DEVIATION REQUEST AND DECISION FORM

Project Name :	Crossroads North
Schedule No.(s) :	5408001008, 5408001029, 5408001032, 5408001033, 5408001034, 5408001041, 5408001042, 5408001050, 5408001051, 5408001052
Legal Description :	LOTS 12, 13, 14, 15, 16 AND 18, HILLCREST ACRES, ACCORDING TO THE PLAT THEREOF RECORDED MAY 12, 1960 AT RECEPTION NO. 153860, EXCEPT THAT PORTION ACQUIRED BY THE DEPARTMENT OF TRANSPORTATION, STATE OF COLORADO AS DESCRIBED IN RULE AND ORDER RECORDED APRIL 28, 2004 UNDER RECEPTION NO. 204068322, AND EXCEPT THOSE PORTIONS CONVEYED TO EL PASO COUNTY BY AND THROUGH THE BOARD OF COUNTY COMMISSIONERS OF EL PASO COUNTY, COLORADO BY SPECIAL WARRANTY DEED RECORDED DECEMBER 17, 2014 AT RECEPTION NO. 214116021 AND RECORDED DECEMBER 17, 2014 AT RECEPTION NO. 214116022, COUNTY OF EL PASO, STATE OF COLORADO. LOT 17, HILLCREST ACRES, COUNTY OF EL PASO, STATE OF COLORADO, EXCEPT THAT PORTION CONVEYED TO EL PASO COUNTY BY AND THROUGH THE BOARD OF COUNTY COMMISSIONERS OF EL PASO COUNTY, COLORADO BY SPECIAL WARRANTY DEED RECORDED DECEMBER 30, 2014 AT RECEPTION NO. 214119767. LOT 19, HILLCREST ACRES, COUNTY OF EL PASO, STATE OF COLORADO, AS AMENDED BY SURVEYOR'S STATEMENT RECORDE

SCALE: NOT TO SCALE

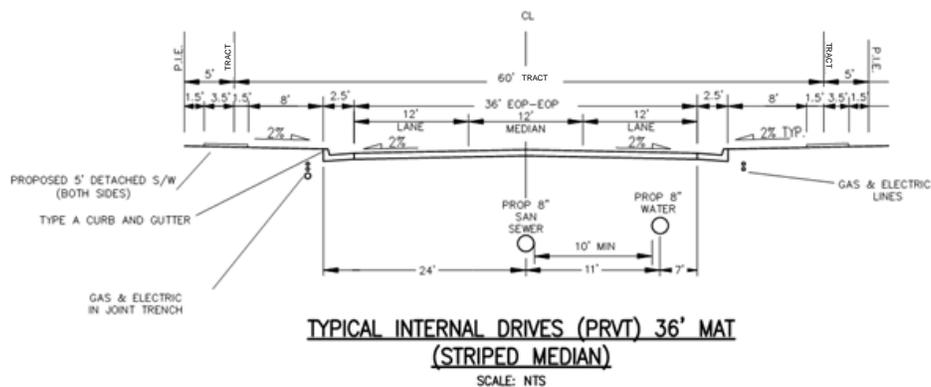
A deviation from the standard Urban Non-Residential Collector Roadway Cross Section for Pro Omnibus Heights, Semper Supra Point, and Nox Album View is requested. The standard cross section includes two travel lanes (12'), a striped median (12'), and two shoulders (6') within a 48-foot wide pavement mat; two 2.5-foot curb and gutter at the end of the pavement mat, two eight (8) foot (typical) landscape/tree lawns, two five (5) foot detached sidewalks all within an 80-foot ROW. A deviation from the minimum centerline radius for Urban Non-Residential Collector Roadways is also requested. The minimum radius is 565 feet.

The proposed private road cross section includes the following deviation(s) from standard ECM Standards for an urban residential collector section. Requesting;

- 60-foot Tract. Typical cross section is within an 80-foot Public ROW.
- 36 foot pavement width, where typical cross section has a 48' pavement width.
- Two 12-foot travel lanes with NO 6' shoulders, where typical cross section has two 12-foot travel lanes with two 6' shoulders.

- Striped 12' median, whereas typical cross section has 12' striped median. No Change.
- 5-foot detached sidewalk, where typical cross section has 5' detached sidewalks, No Change.

- 200' minimum centerline radius (standard for urban local roadways) whereas typical cross section is 565' minimum centerline radius.
- Two 5' Public Improvement Easements, whereas typical cross section has none.

- Two 8' landscape/tree lawns. Typical cross section has two 8' landscape/tree lawns. No. change.
- 25 MPH design speed/25 MPH posted speed (urban local), whereas typical cross section is 40/35 MPH.

- Typical cross section intersection spacing is 660' or 330' when intersecting local roadways. The layout of all of the commercial lots is not known at this time. Therefore, a deviation for the future applications will be necessary. Direct lot access allowance in conformance with ECM Section 2.4 is implied with this deviation for Lots 4-9. Additional access spacing may also need to be considered. (Table 2-35)
